Access Compliance Report

Public Rights-of-Way

Intersection ID: 26929	Main Street: ALEXA_RD	Cross Street: WATERBROOK_LN	Location: SW
ADA ID: D7BAAF3155C1	Ramp Type: PerpDiag	Initial Pass/Fail: Fail	Overall Compliance: No
		Severity Score: 1.25

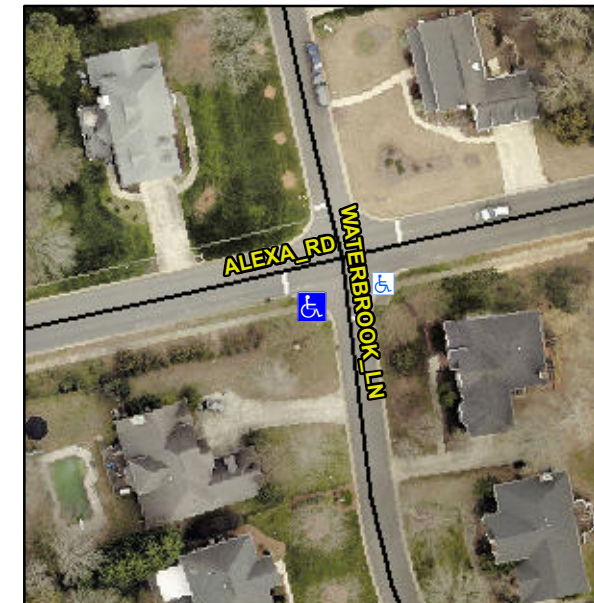
Not Found, R304.5.3

Compliance	Description	Data	Compliance	Description	Data
N/A	Ramp Length (in)	48.0	Yes	Ramp Slope (%)	5.7
Yes	Ramp Width (in)	64.0	No	Ramp XSlope (%)	3.8
N/A	Flare Type LT	N/A	N/A	Flare Type RT	N/A
N/A	Flare Slope LT (%)	N/A	N/A	Flare Slope RT (%)	N/A
N/A	Flare Traversable LT?	N/A	N/A	Flare Traversable RT?	N/A
N/A	Landing Length (in)	N/A	N/A	DWS Provided?	N/A
N/A	Landing Width (in)	N/A	N/A	DWS Contrast?	N/A
N/A	Landing Slope (%)	N/A	N/A	DWS Length (in)	N/A
N/A	Landing X Slope (%)	N/A	N/A	DWS Full Width?	N/A
N/A	Landing Curb? (Y/N)	N/A	N/A	DWS Offset (in)	N/A
N/A	Shared Landing?	N/A			
N/A	Gutter Ponding?	N/A	N/A	Gutter Slope (%)	N/A
N/A	Gutter Lip Ht (in)	N/A	N/A	Gutter X Slope (%)	N/A
N/A	Painted X Walk1?	No	N/A	Painted X Walk2?	No
	X Walk 1 Direction	To E		X Walk 2 Direction	To N
N/A	X Walk 1 Width (in)	N/A	N/A	X Walk 2 Width (in)	N/A
	X Walk 1 Slope (%)	0.1		X Walk 2 Slope (%)	0.3
	X Walk 1 X Slope (%)	3.3		X Walk 2 X Slope (%)	0.3

Remove & Replace Curb Ramp With Two New Directional Ramps or Equivalent.
